RECEIPT DATE: 5/27/20 **ONSITE SEWAGE DISPOSAL SYSTEM** P 567852-B

APPROVAL DATE: 7/21/2020 **PERMIT: CONSTRUCTION** A \_\_\_\_\_

PROPERTY ADDRESS: 1018 HIGH STEPPER TRAIL, SYKESVILLE, MD 21784

LOT 8 ONSITE SEWAGE  
DISPOSAL SYSTEM DESIGN PLAN

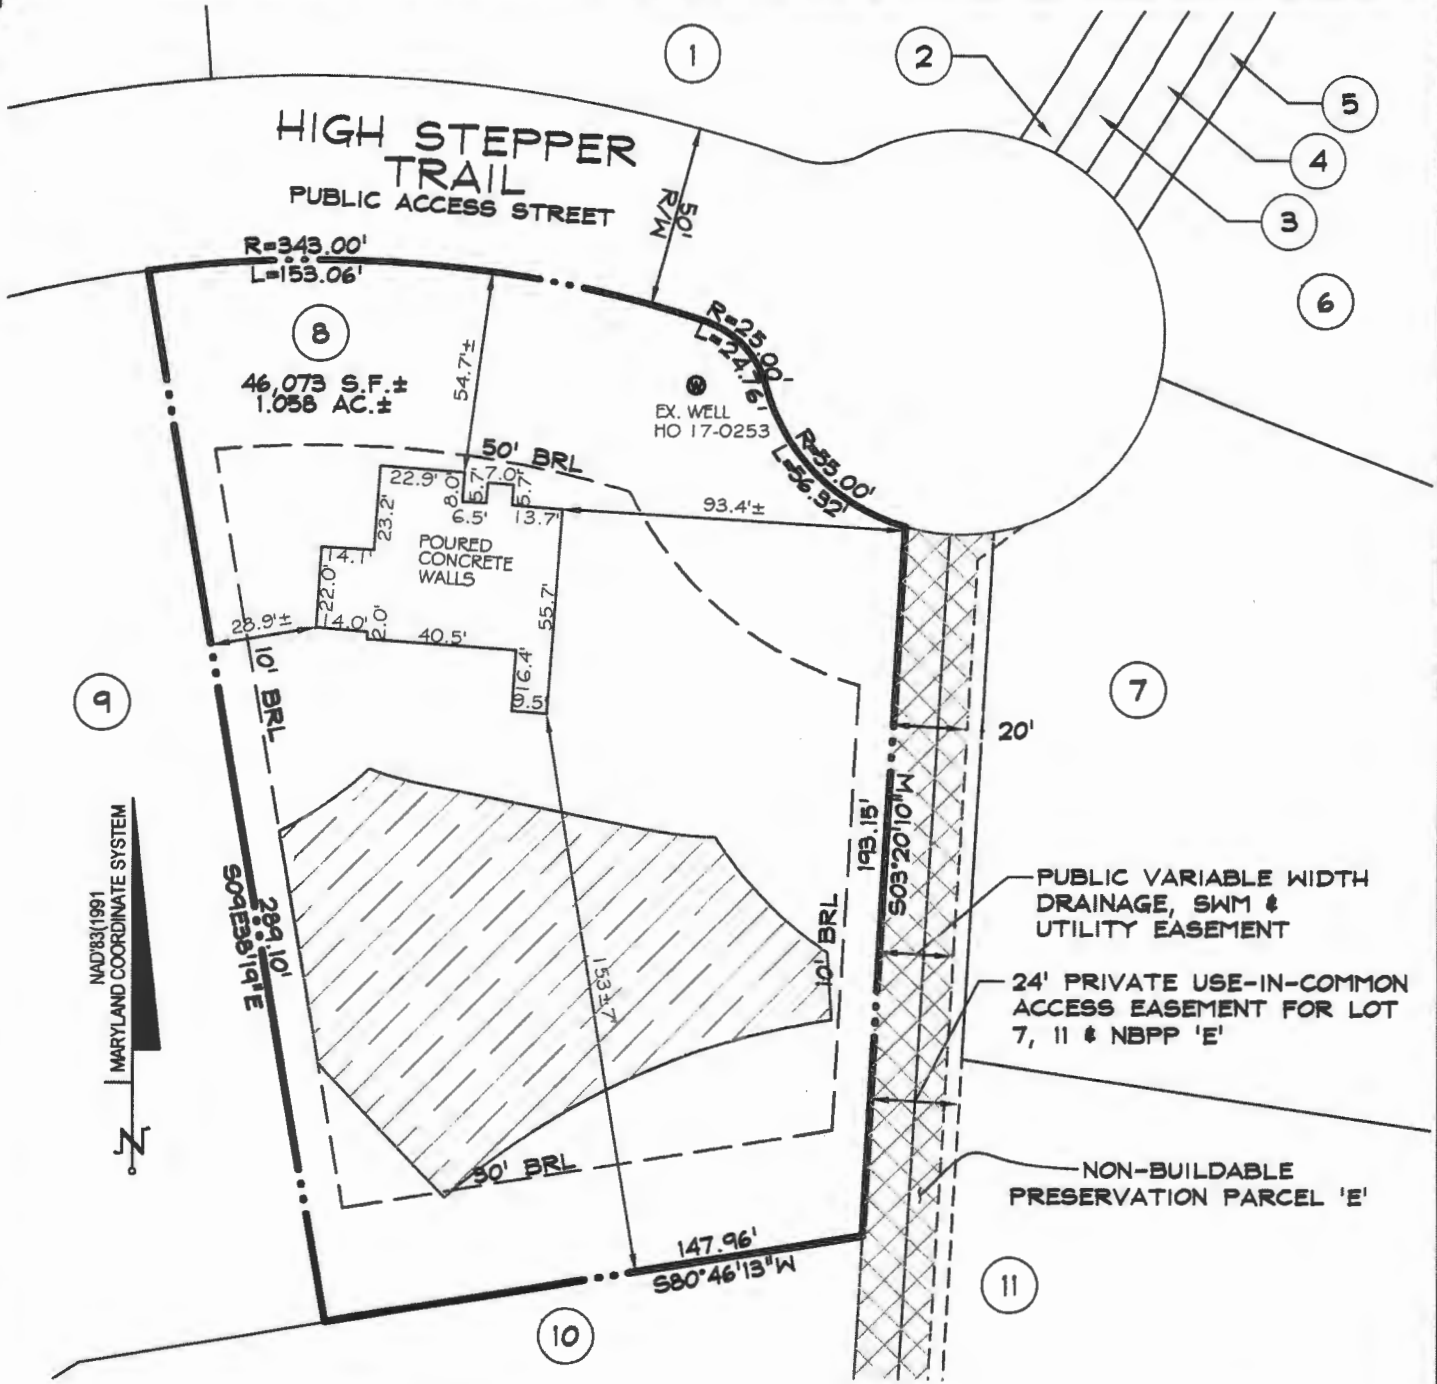
06/05/2020 SEWER OUT OF HOUSE CHANGED; FINISHED BASEMENT. LAID OUT 1X 83' TRENCH. OK (✓)

INSTALLATION: 06/05/2020 TANK AND SI INSTALLED. REINSPECT SHC (✓)  
06/08/2020 D BOX SET; TRENCH COMPLETE. NO NEED FOR SPEED LEVELS AS THERE IS ONLY ONE TRENCH. REINSPECT SHC (✓)  
SHC confirmed via builder (✓)

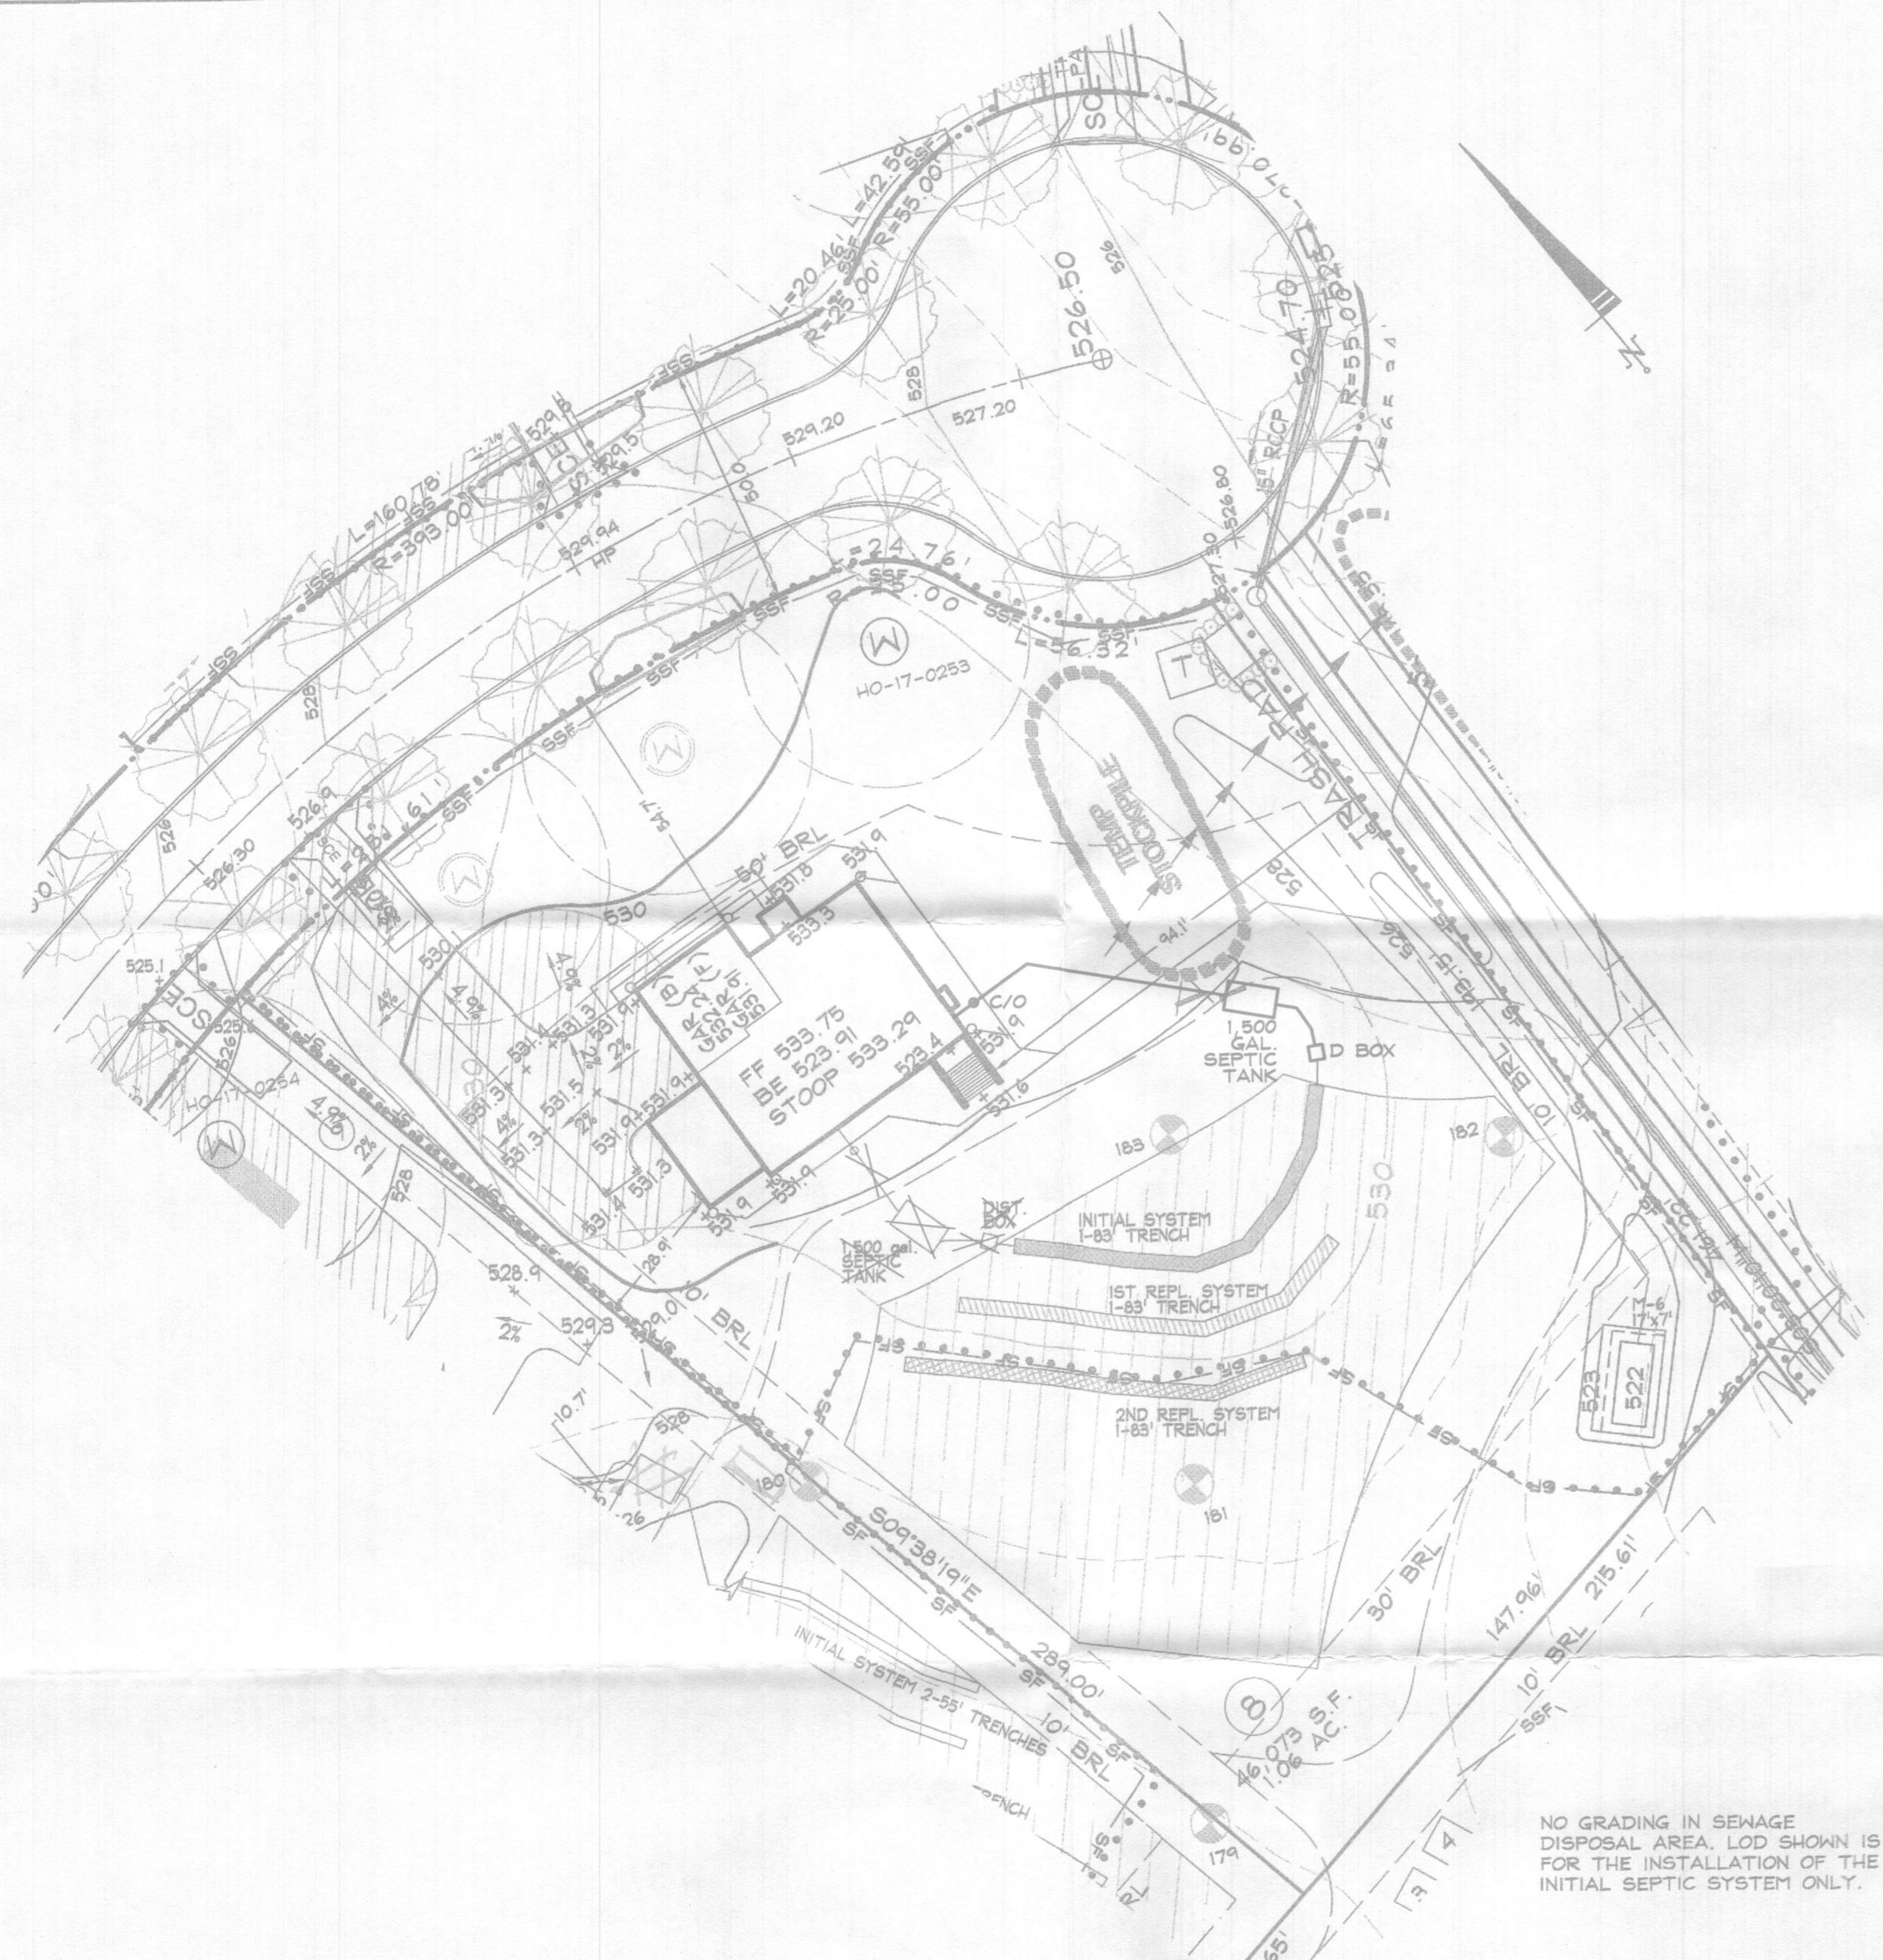
REVISIONS			
NO.	DESCRIPTION OF CHANGES	DRN/REV	DATE
1	LOT 8 REVISED TANK LOCATION	LJC	5/22/20
CO. FILE #:	F-17-045	DES. BY:	LJC
TAX ACC. #:	03-601568	DRN. BY:	LJC
TAX MAP:	9	CHK. BY:	WRD
BLOCK / GRID:	6	DATE:	2/24/20
PARCEL #:	66	DDC JOB#:	12064.3
ZONE / USE:	RR-DEO	SHEET NUMBER:	
DWG. SCALE:	1" = 30'		1 of 1

LOT 8 REVISED  
TANK LOCATION

Redline revision 'OK'  
RB 4/26/2020

LOT 8 ONSITE SEWAGE DISPOSAL SYSTEM DESIGN PLAN

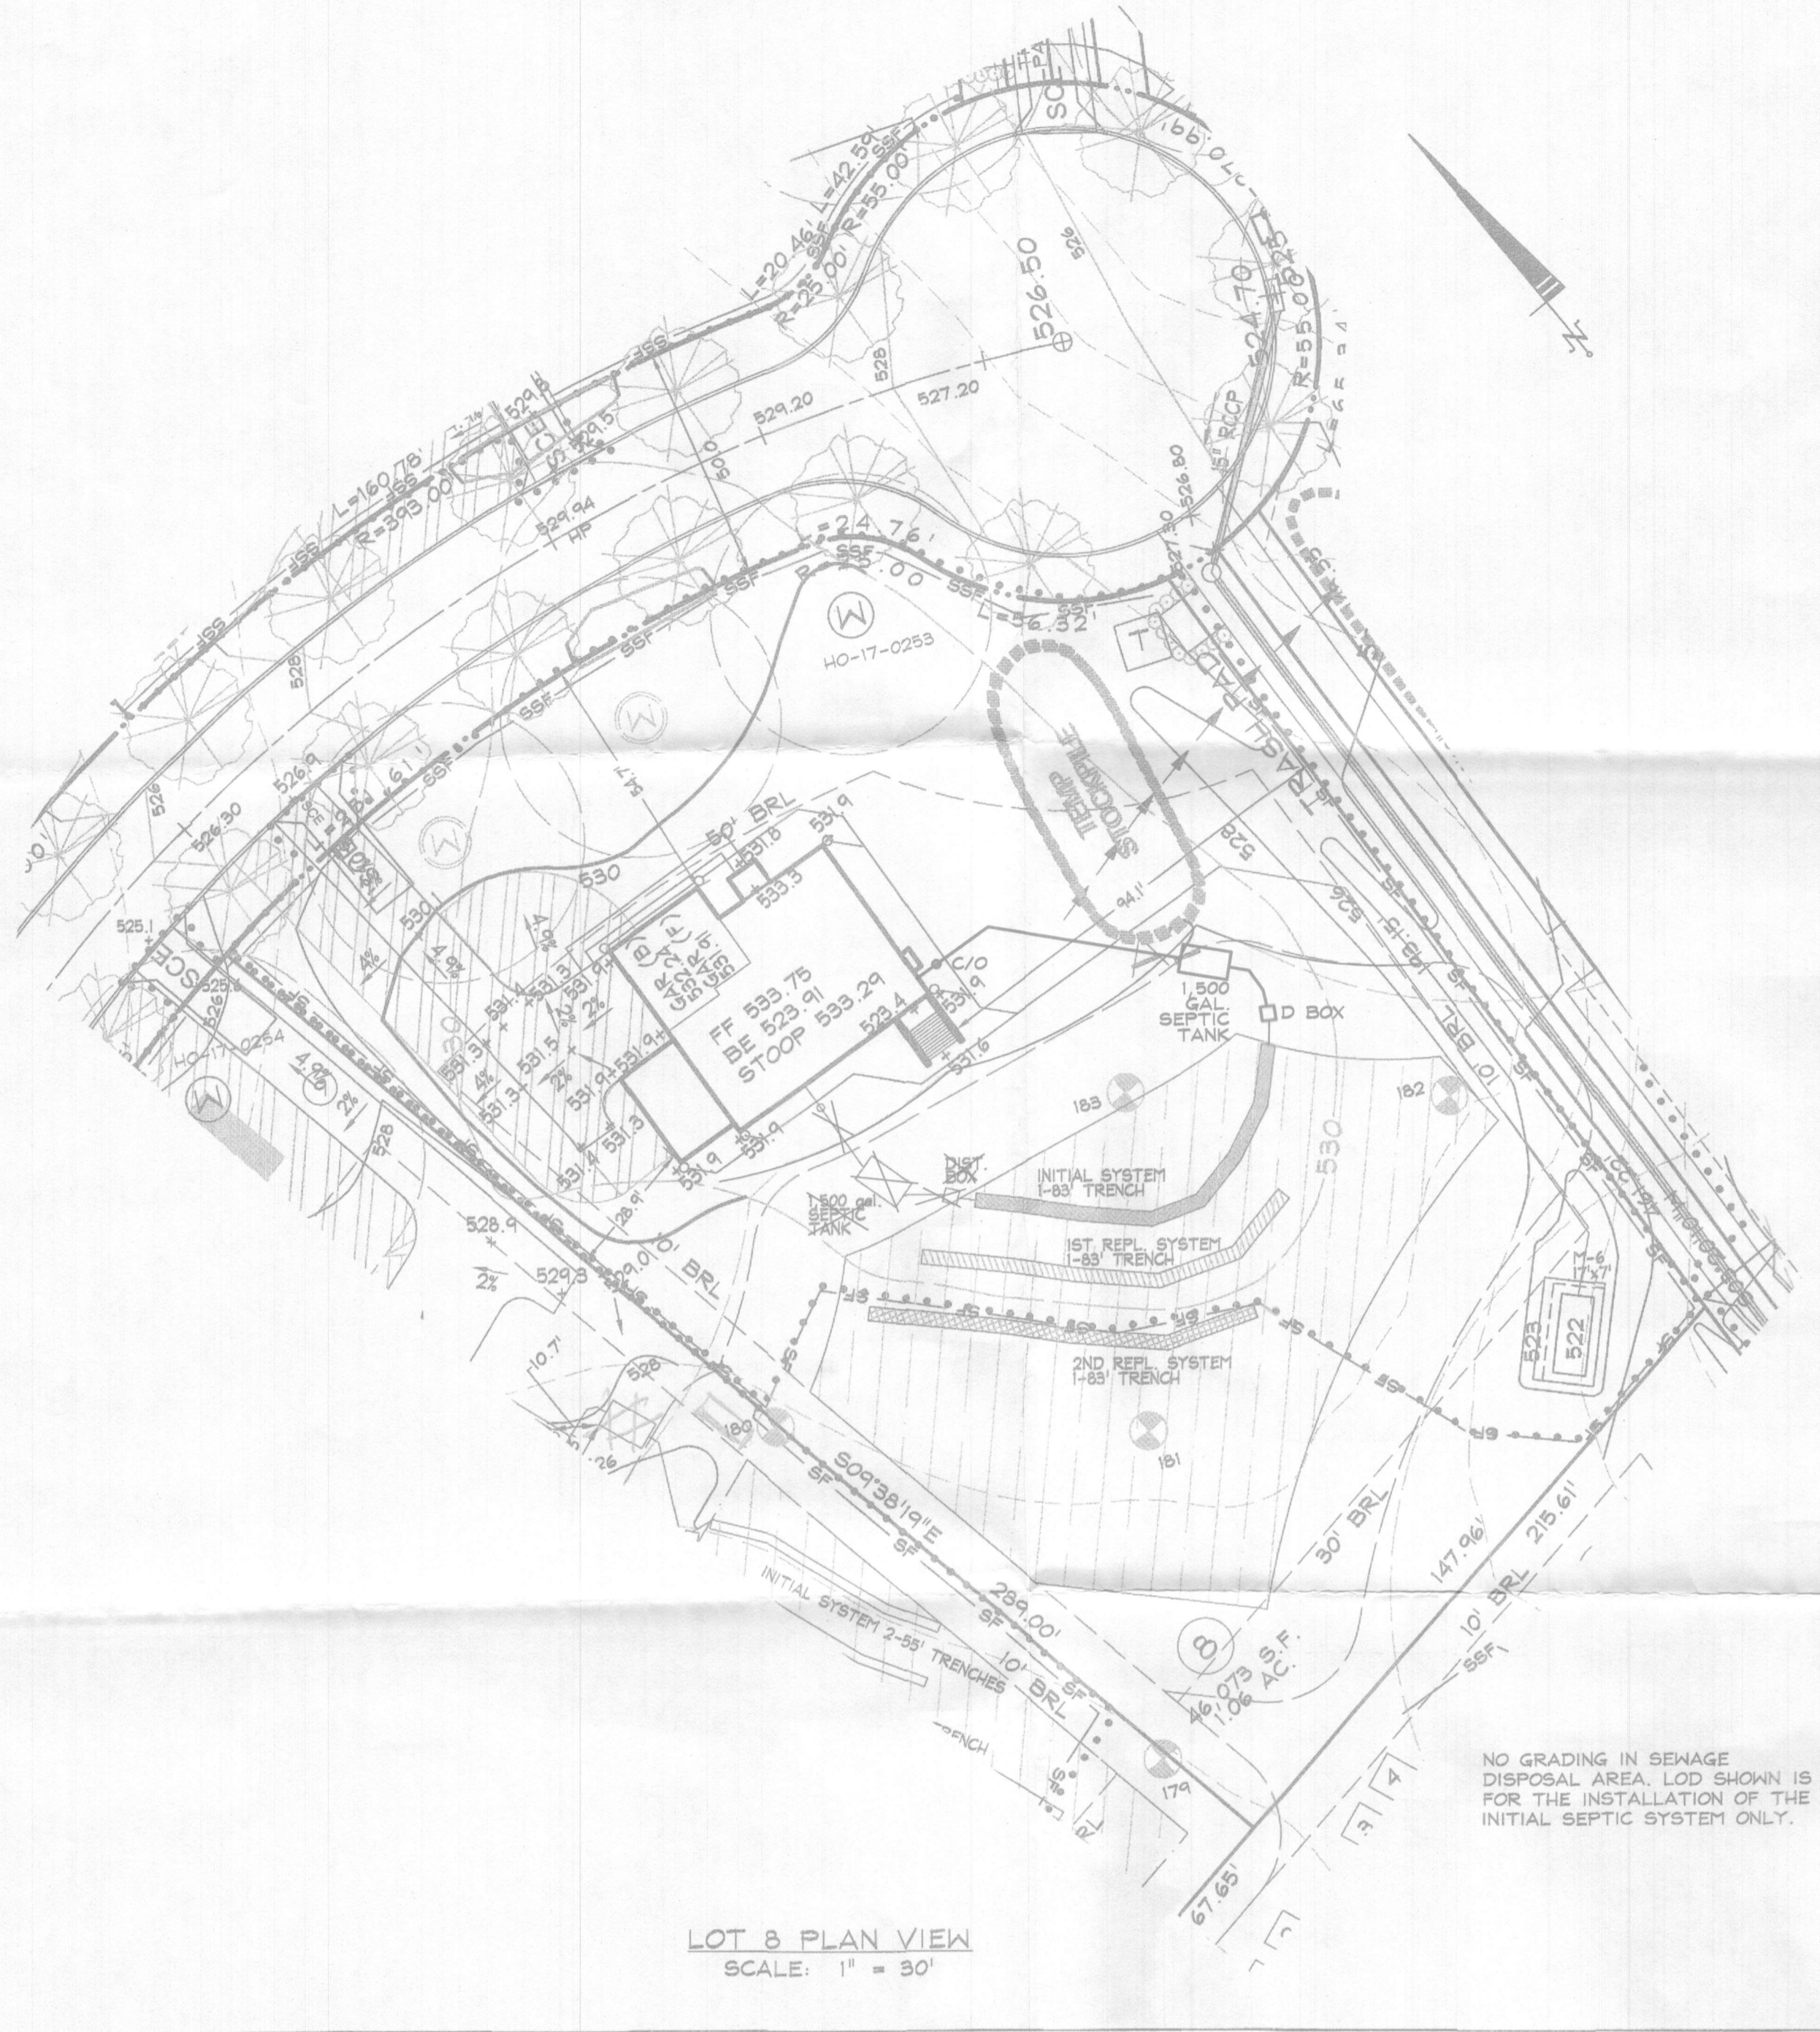
LOT 8 REVISED TANK LOCATION

NO.	DESCRIPTION OF CHANGES	DRN. REV.	DATE
1	LOT 8 REVISED TANK LOCATION	LJC	5/22/20

*Redline revision OK!*  
 RB 6/26/2020
